PRELIMINARY PROJECT ASSESSMENT

Project Address: 1355 Fulton Street
Case Number: 2018-005393PPA
Date: June 8, 2018
To: Leanne Lei, Sia Consulting Group
From: David Lindsay, Planning Department
Christopher May, Planning Department

The proposal is to construct an 8-story vertical addition above the existing 13,781-square-foot auto repair garage building to add approximately 61,348 square feet to accommodate 75 dwelling units. The existing building on the 12,031 square-foot subject lot was constructed in 1922. The proposed project would include 35 vehicular parking spaces, 75 bicycle spaces, and 2,142 square feet of commercial space along Fulton Street. The project seeks to obtain increased residential density via the Individually-Requested State Density Bonus Program, under which project sponsors are entitled to increase the development capacity of a project by up to 35% in exchange for providing on-site affordable housing units. Under the law, the additional density provided is in addition to what would be allowed by an equivalent project that is Code-complying.

Title: 1355 Fulton Street - PPA Initial Shadow Study

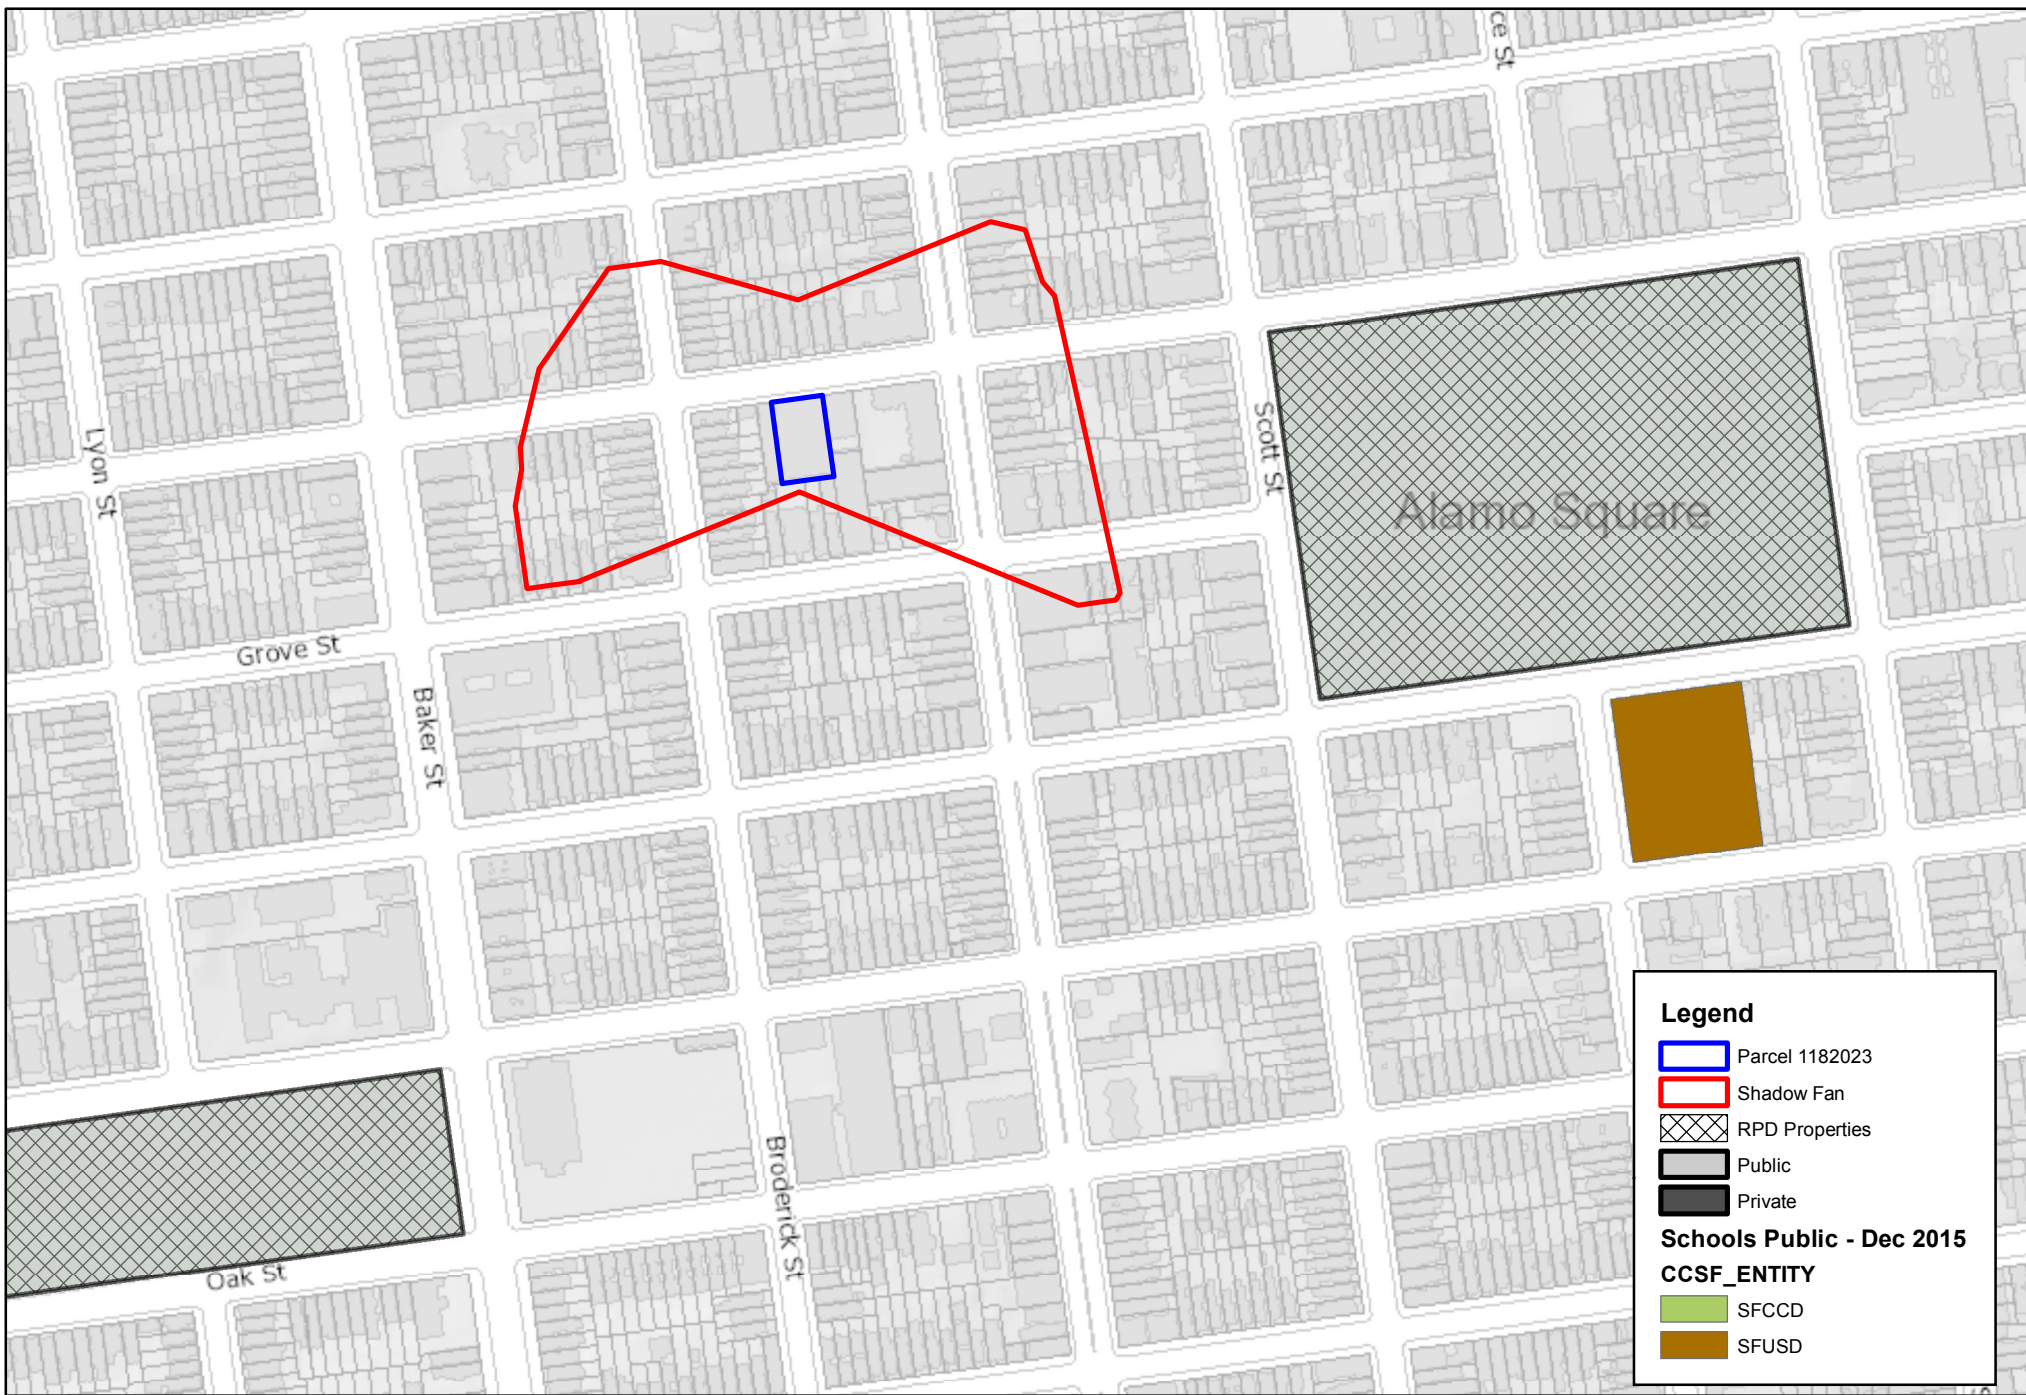
4.3	Shadow	Shadow Fan	<input type="checkbox"/> YES <input checked="" type="checkbox"/> NO	Department prepared the attached shadow fan which shows no new shadow on outdoor recreation facilities or other public areas.

Comments: 85' proposed residential building
